**Response to Public Comment on the Draft
2018 Section 303(d) List of Impaired Waters
and the Draft Consolidated Assessment and Listing
Methodology**

August 8, 2019

**STATE OF NEW HAMPSHIRE
DEPARTMENT OF ENVIRONMENTAL SERVICES
29 HAZEN DRIVE
CONCORD, N.H. 03302**

Figure 1: Percentile distribution of all valid freshwater samples collected for chlorophyll-a between 1/1/1990-4/18/2018

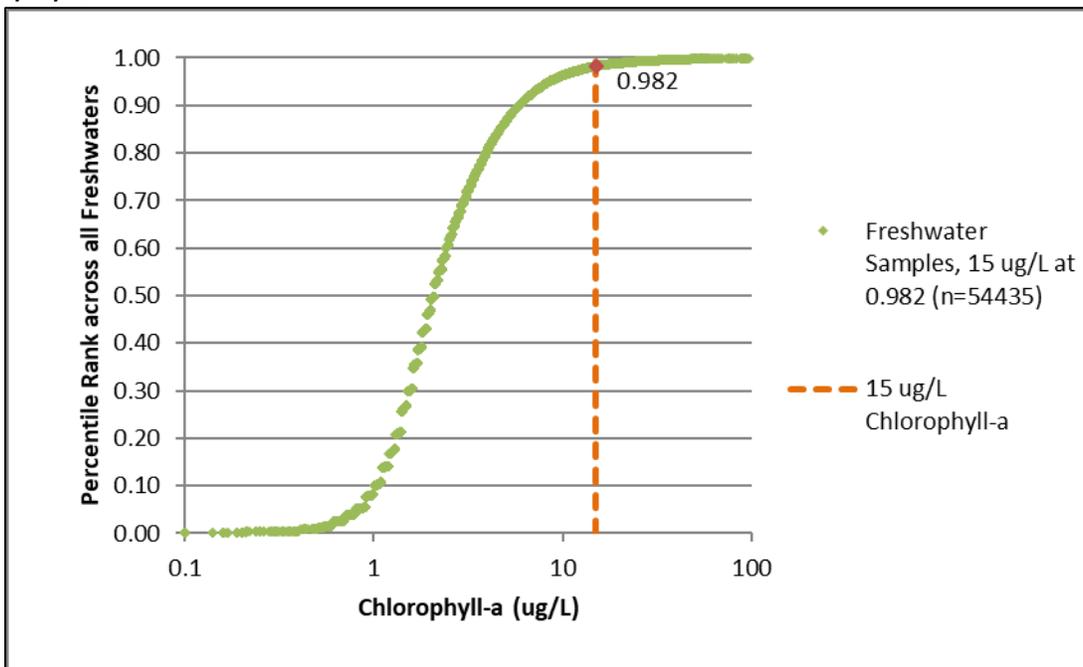
NHDES’ 15 µg/L chlorophyll-a threshold for the primary contact recreation designated use (NHDES, 2019a) was not developed with regard to a particular method. Therefore, it is applicable to compared both

chlorophyll-a corrected for pheophytin and chlorophyll-a uncorrected for pheophytin to this threshold. The rationale for the development of the chlorophyll-a threshold, exclusive of method, was due to the fact that both chlorophyll-a and pheophytin absorb light in nearly the exact same region of the light spectrum making the water appear green to the casual observer. It is a common misconception that a waterbody that is impaired for chlorophyll-a for the primary contact recreation designated use is always green in color and/or algal blooms are constantly present. However, these types of visual cues are intermittent and not always spotted by the public. An evaluation of the existing chlorophyll-a data (both corrected and uncorrected for pheophytin) available for New Hampshire’s freshwaters indicates that a 15 µg/L chlorophyll-a concentration is a very rare event (**Figure 1**), landing at the 98th percentile.

Figure 5: pH in the Merrimack River (NHRIV700061206-24)

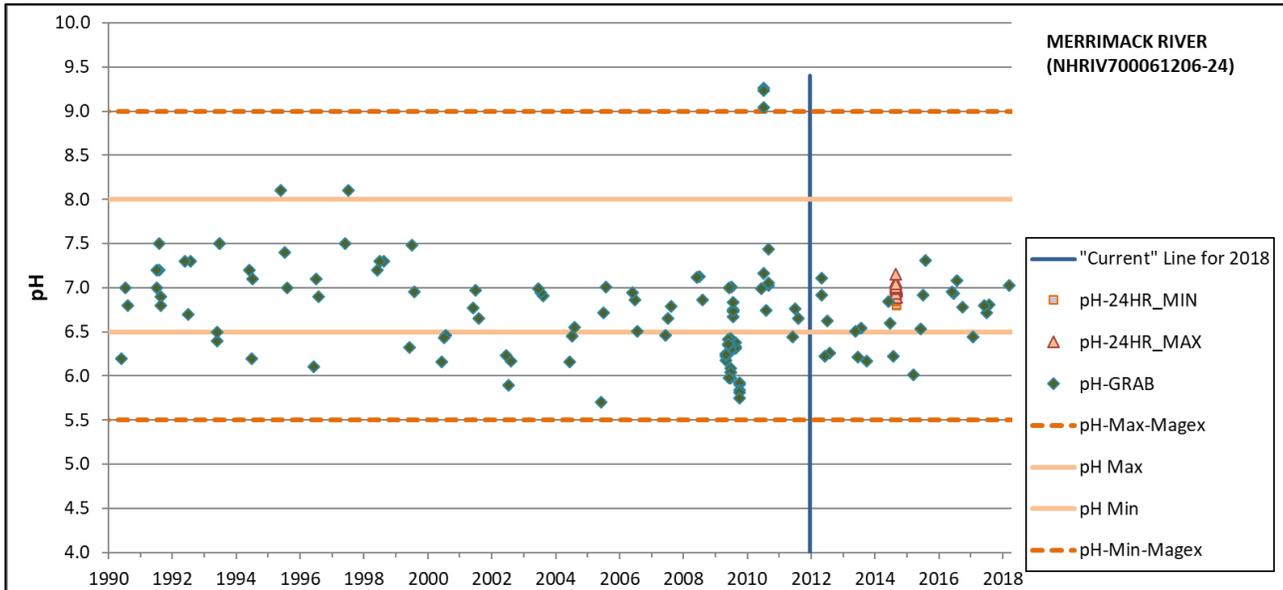
This comment takes issue that there is not alignment between NHDES’ assessments and a modeling study of the Merrimack River by CDM-Smith, in coordination with the USACOE. The commenter briefly references that the model indicates that there are no violations of the prime drivers of pH. It is not clear from the comments if this was a typo or intentional, as the commenter provides no context to the comment, no specific assessment unit, and no justification for their belief. Of the two assessment units for which the commuter has raised other concerns, only NHRIV700061206-24 has a pH impairment. However it is clear from **Figure 5** that this assessment unit experiences both low pH due to acid precipitation on poorly

buffered soils and high pH due to swings associated with high productivity like that seem on 7/27/2010 and 9/21/2010, when the Chlorophyll-a level reached 20 µg/L (Figure 10).

Figure 6: Dissolved Oxygen Concentration in the Merrimack River (NHRIV700060302-25-02)

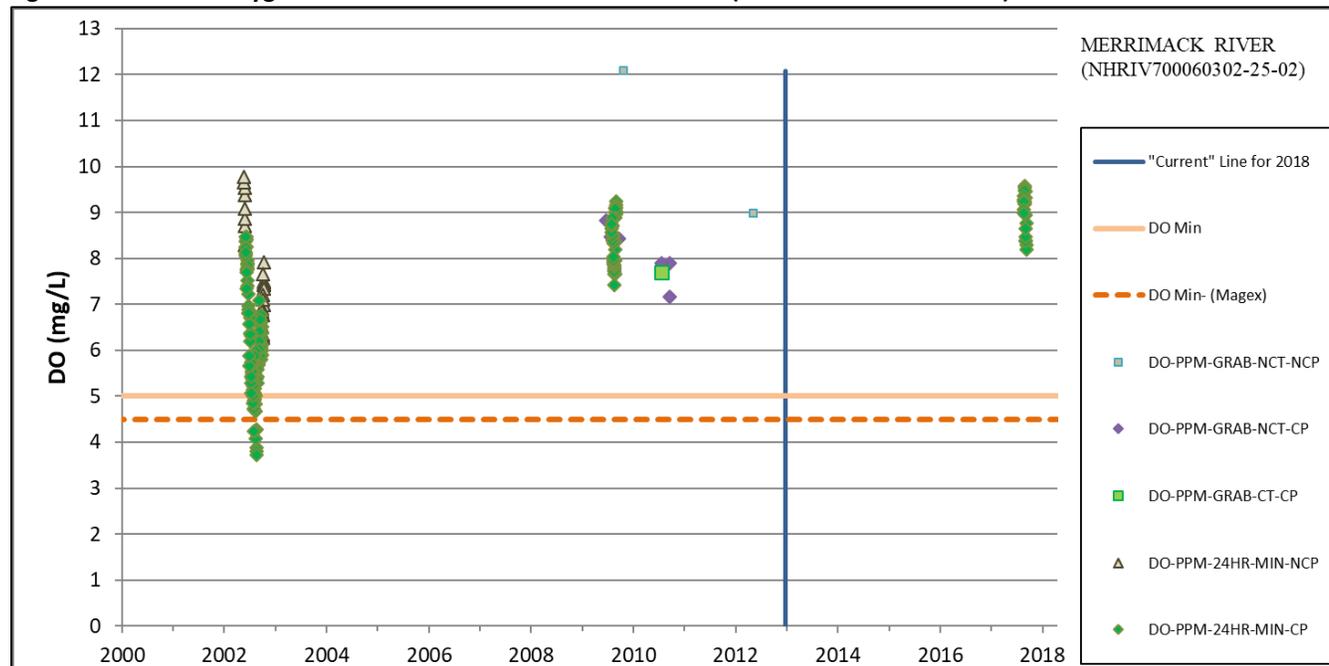
The commenter further disagrees with NHDES' impairment of the mainstem Merrimack River (NHRIV700060302-25-02) for dissolved oxygen concentration for the aquatic life integrity designated use, and the Merrimack River (NHRIV700061206-24) for chlorophyll-a for the primary contact recreation designated use. As addressed in comments 5- 2 and 5- 3, above; the model referenced by the commenter is a simplification of real world conditions, and has limitations based on its spatial resolution (CDM-Smith, 2018). The data used by NHDES to make assessment decisions must be of high quality and defensible. Although modeled conditions can be used in assessment determinations, they do not supersede physical data when the physical data demonstrates water quality thresholds are not being met.

Figure 6 illustrates the dissolved oxygen data within the Merrimack River (NHRIV700060302-25-02) that was used in the 2018 assessments. At first glance it appears to demonstrate that conditions within this stretch of the river have been improving since first sampled in 2002. However, understanding the data that was used in the original listing is critical when evaluating the newer data for possible consideration of a delisting. The newer data must be comparable to the original data in as many ways as possible. Specifically, the data must be collected at the same station and under the same (or more limiting) conditions as the original data that showed problems (NHDES, 2019b).

Figure 14: Light Attenuation in the Bellamy River

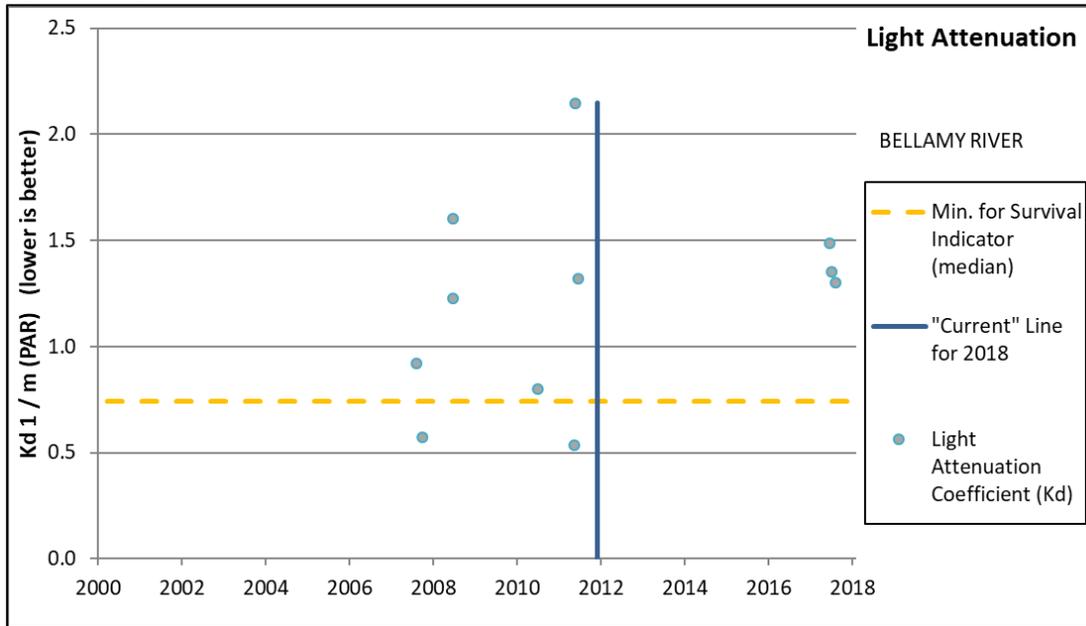
The commenter objects to NHDES’ decision to impair the Bellamy River for light attenuation for the aquatic life integrity designated use. NHDES’ draft 2018 assessment of light attenuation for the Bellamy River assessment zone (NHEST600030903-01-01, NHEST600030903-01-03, and NHEST600030903-01-04) placed it in category 5-M. This decision was based in part on the light attenuation data collected in the Bellay River itself, as well as that of the boundary waters (Little Bay assessment zone). As can be seen in **Figure 14** all of the light attenuation measurements within the current period far exceeded the restoration depth based threshold of 0.75 m⁻¹, as have 9 of the 11 sampled ever collected in this assessment zone (NHDES, 2019c). NHDES recognizes that there were only three samples collected within the current period, which is far less than the 15 required per the CALM, however NHDES also took into account the light attenuation values in Little Bay that flows into the Bellamy River on an incoming tide. As one can see in **Figure 15**, the waters of Little Bay are routinely well above restoration depth based threshold of 0.75 m⁻¹. NHDES surmised that during an incoming tide the waters from Little Bay would flow into and mix with the waters of the Bellamy River. This mixing of waters would create light attenuation values that were very similar between the two waterbodies during an incoming tide.

Figure 17: Great Bay Eelgrass Acreage at Various Depth Regimes

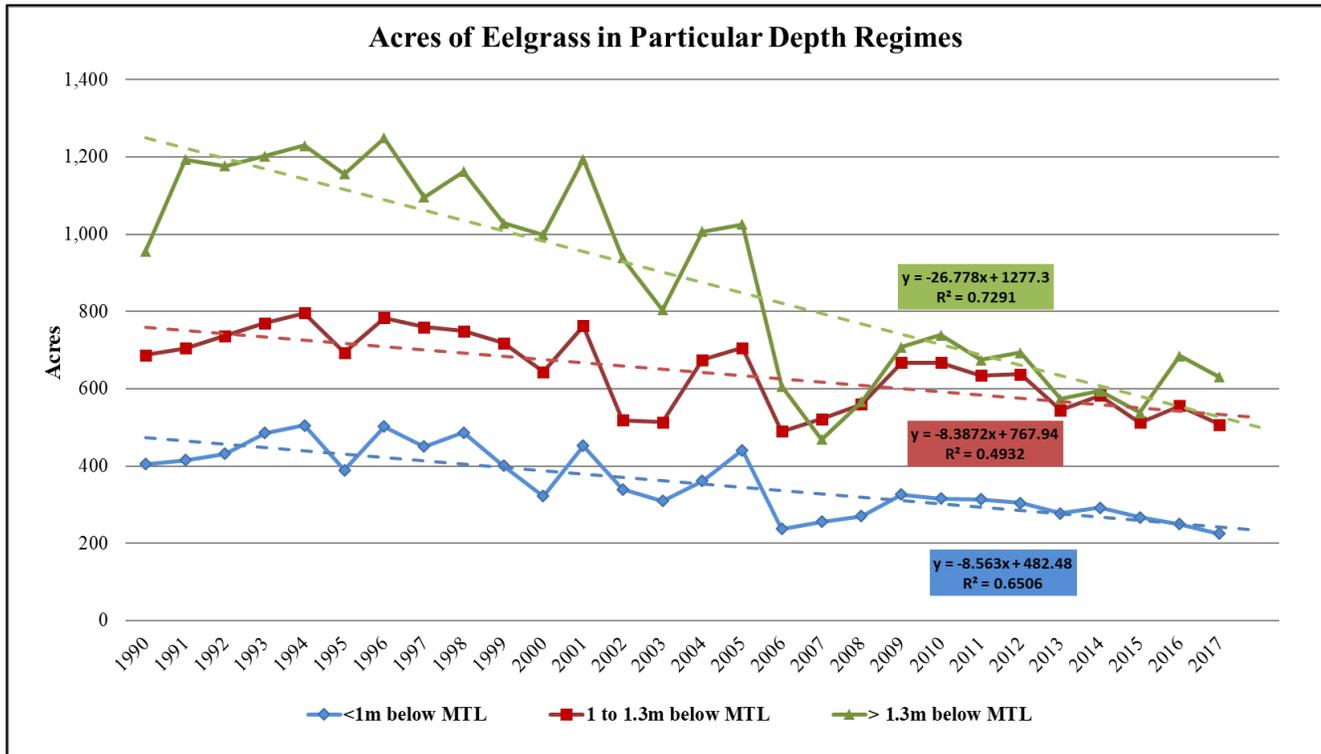
This comment argues that the restoration depth based threshold of 0.75 m⁻¹ is not applicable due to the fact that eelgrass losses have not occurred primarily in deeper waters. The commenter contends that they have raised this issue in their previous comments on the 2014 and 2016 draft assessment material, but they feel the argument is still applicable. NHDES' position has not changed on this subject since the issuance of the [2014 Response](#) and [2016 Response](#) to comments (NHDES, 2017a) (NHDES, 2017b).

NHDES continues to disagree with the commenter's claim that "most losses of eelgrass in Great Bay occurred in shallower waters." The Great Bay Eelgrass Depth Analysis (Wood, 2016), which was presented as part of the 2014 Response to Comments clearly demonstrates that eelgrass is being lost throughout Great Bay, and the rate of loss is greatest in the sub-tidal zone with unacceptable light anticipated (> 1.3m below MTL). NHDES has updated the underlying data used in that analysis to include all the data that was used in the 2018 draft assessments. As evident from **Figure 17** and **Table 4**, eelgrass is being lost throughout Great Bay. The rate of loss is approximately -8.5 acres/yr within the intertidal zone (<1m below MTL) and the sub-tidal zone with acceptable light anticipated (1 to 1.3m below MTL). In contrast, the rate of loss within the deeper sub-tidal zone with unacceptable light anticipated (> 1.3m below MTL) is nearly three times that of the other two depth regimes, at a rate of -26.8 acres/yr. This is a direct contradiction to the commenters claim that the shallower waters have the most loss of eelgrass.

Figure 18: Station GRBSQ Location

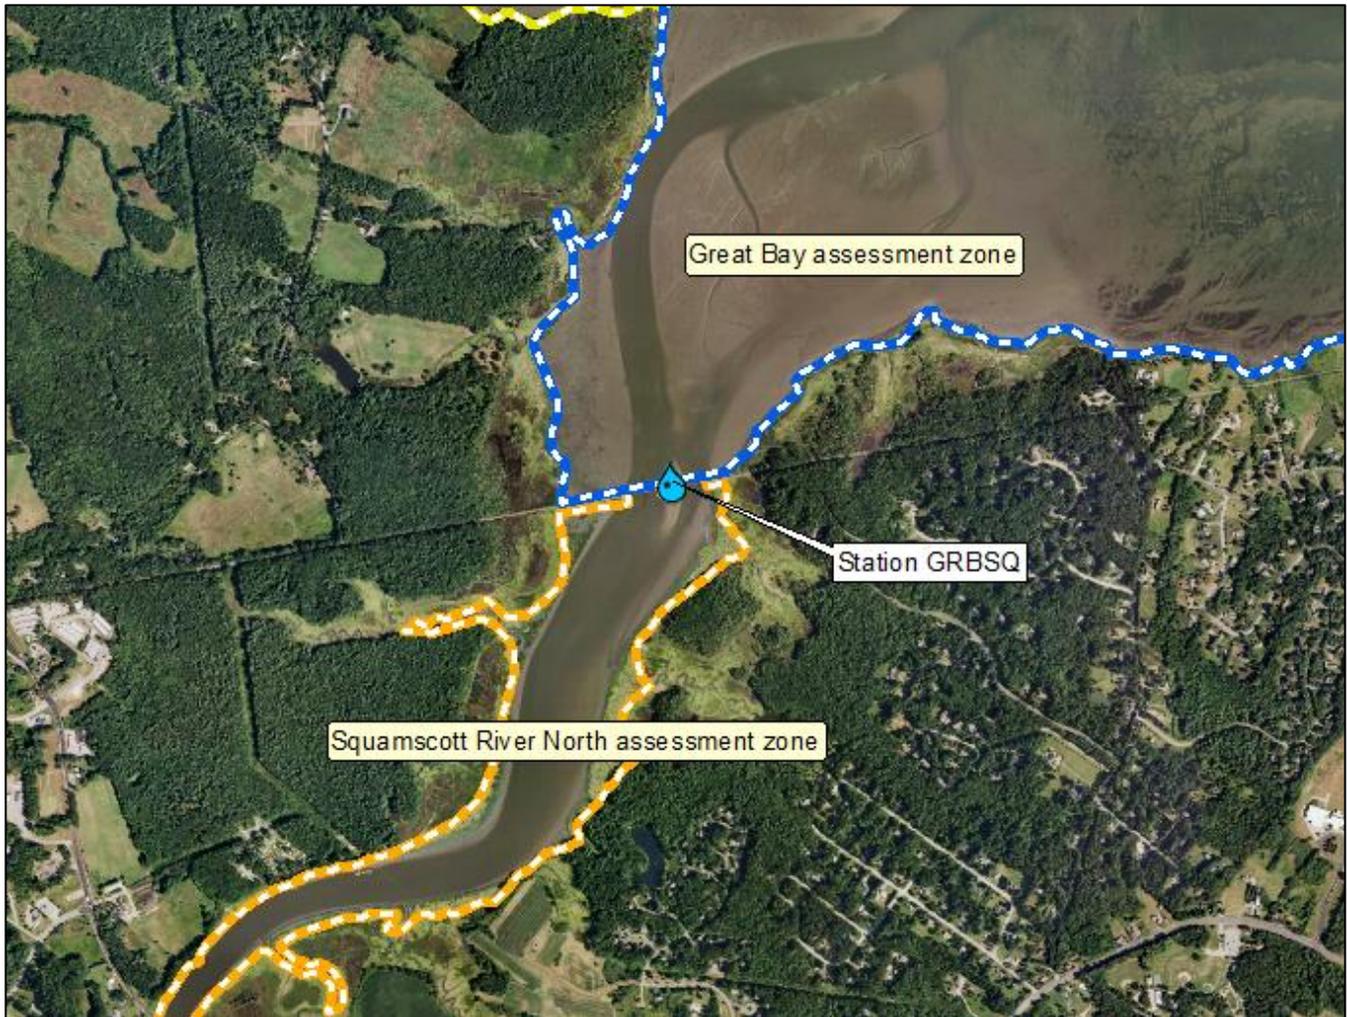
This section of the comments revisits past concerns that sampling locations on the boundary of a waterbody can only be used for assessment on one waterbody. The commenter further requests that graphics in the Technical Support Document (NHDES, 2019c) depicting total nitrogen in Great Bay that include the Squamscott River station. Great Bay is not currently impaired for total nitrogen, therefore these comments are not specific to the 2018 draft 303(d) List, and therefore do not require a response. NHDES would like the commenter to understand that water flowing from one waterbody into another waterbody can have a profound effect on the receiving waterbody's water quality. Therefore, it is not only appropriate, but imperative, to consider these types of monitoring stations when evaluating a waterbody. We cannot ignore the influence that a waterbody with different water quality might be having on the receiving water, especially in a system that is tidally influenced, where flows change direction. As shown in **Figure 18**, station GRBSQ is directly on the boundary between the Great Bay and Squamscott River North assessment zones. Depending on the tidal conditions at the time of sample collection, this station has the potential to more closely represent the water quality in Great Bay (flooding tide), the Squamscott River (ebbing tide) or a mixture of the two waterbodies (slack tide). But perhaps most importantly, station GRBSQ always represents the water quality at that exact location. Because the environmental conditions do not adhere to the man-made boundaries defined by NHDES it is appropriate to utilize the data collected at this station when evaluating both assessment zones.

Figure 19: Chlorophyll-a Concentrations from Grab Samples Collected in the Cocheco River

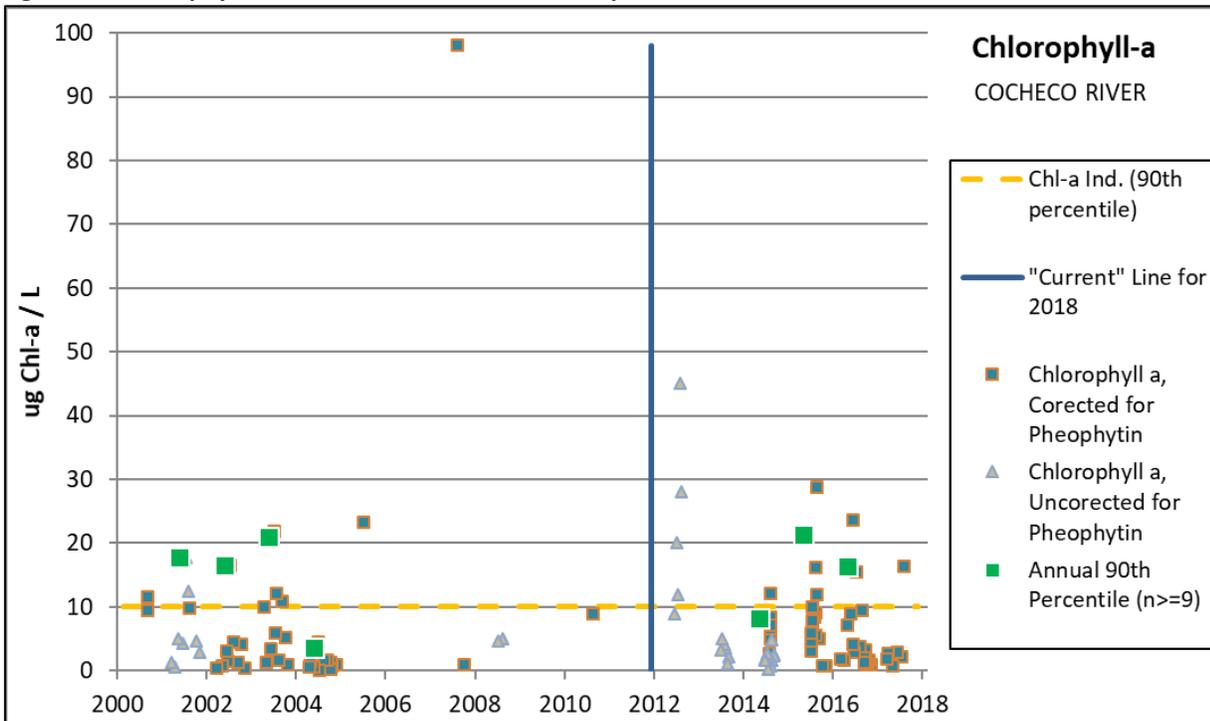
The commenter offers as an example the fact that the highest total nitrogen concentration observed within the last 4 years (2014) was associated to the lowest annual chlorophyll-a 90th percentile. As evident when looking at **Figure 19**, the lowest annual chlorophyll-a 90th percentile within the current period was recorded

in 2014 (7.8 µg/L). However, one should understand that the 7.8 µg/L was calculated from 20 discrete chlorophyll-a samples collected over the course of the growing season. When those data points are overlaid by the uncorrected chlorophyll datalogger data that were collected at the same time (**Figure 20**), it becomes apparent that the chlorophyll grab samples were collected when the concentrations were relatively low, as evident by the continuous datalogger track.

Figure 26: Estuarine Salinity During the Peak Contact Recreation Season (May 24 to September 15)

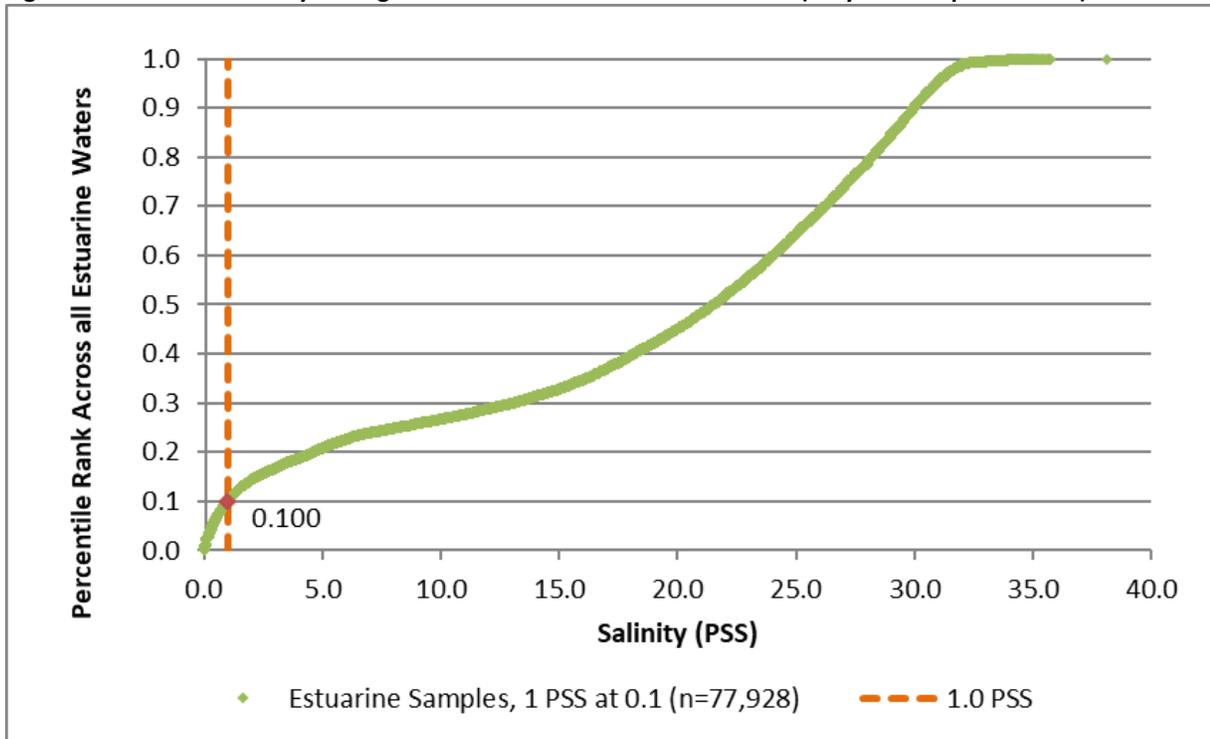
The commenter notes that light and hydraulic residence time in the estuary can control algal growth. While true, no amount of light or residence time will produce algal biomass in the absence of nitrogen to feed that biomass. Along those lines, the commenter also claims, without supporting evidence, that the upper estuary can at times be phosphorus limiting. It's true that the portions of the estuary can at times demonstrate low salinity levels (**Figure 26**), and appear to be freshwater dominated (< 1.0 PSS) (USGS, n.d.). However, these conditions are variable and can change from one day to the next depending on the tides, weather, or other factors, but for the most part these conditions are short in duration. As presented in the 2018 CALM (NHDES, 2019a), the estuarine eutrophication model used by the National Oceanic and Atmospheric Administration relates external nutrient inputs to primary and secondary symptoms of eutrophication (Bricker, et al., 2007). Until such time that sufficient data has been collected that demonstrates that nitrogen is not the limiting nutrient in the system, the impairments will be specifically for nitrogen because the preponderance of scientific evidence supports that nitrogen is the limiting nutrient in marine waters.

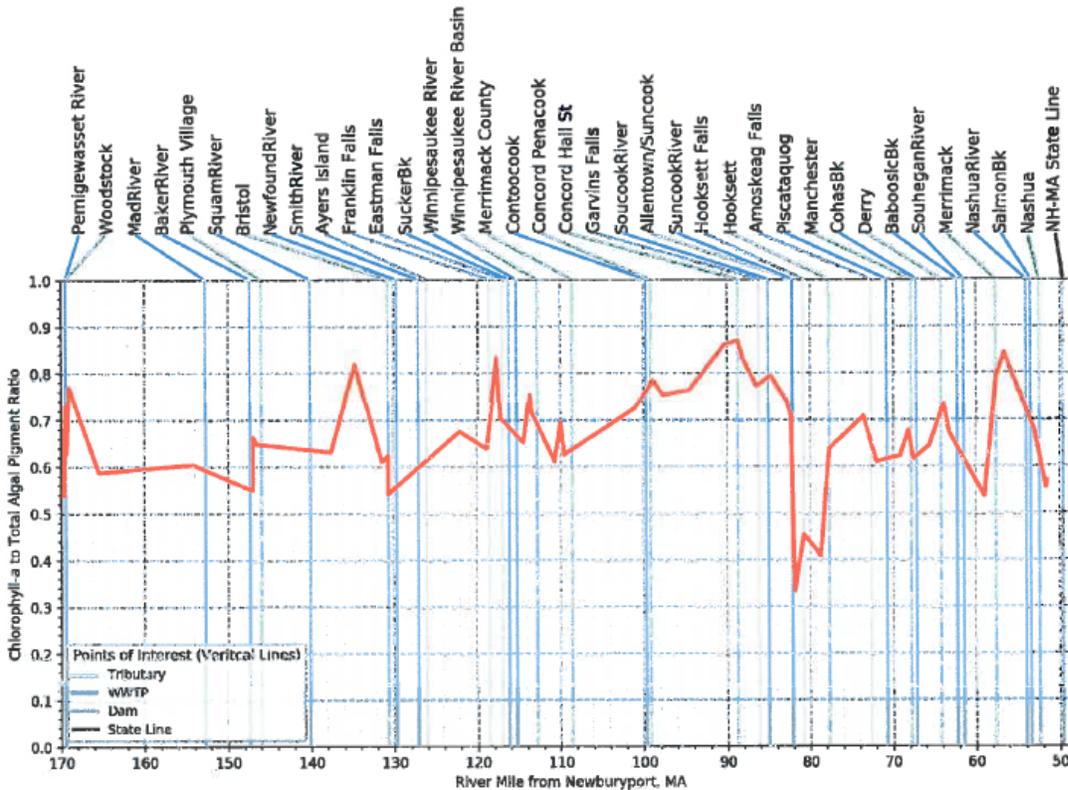
<p>The study was extensive and did note that chlorophyll-a was higher in the furthest reaches of the Merrimack River and at the Massachusetts boundary. The study included an extensive in-vitro sampling event in three phases. The sampling indicated at the state line with Massachusetts, the chlorophyll-a measurement was 16 ug/l and 17 ug/l downstream of the MWWTP. As part of the QA/QC review, it was discovered that pheophytin interfered with</p>	<p>5- 3</p>

chlorophyll-a concentrations and gave an artificially high count/results. The CDM-Smith study listed the magnitude of the interference in the Phase III Report.

As indicated in the chart above, chlorophyll-a to total pigment ratio at the Merrimack sample station is 80%. When this ratio is applied to the 17 ug/l measurement, the concentration of true chlorophyll-a is 13.6 ug/l. This level is in compliance with the NHDES 15 ug/l chlorophyll-a concentration for contact recreation (swimming).
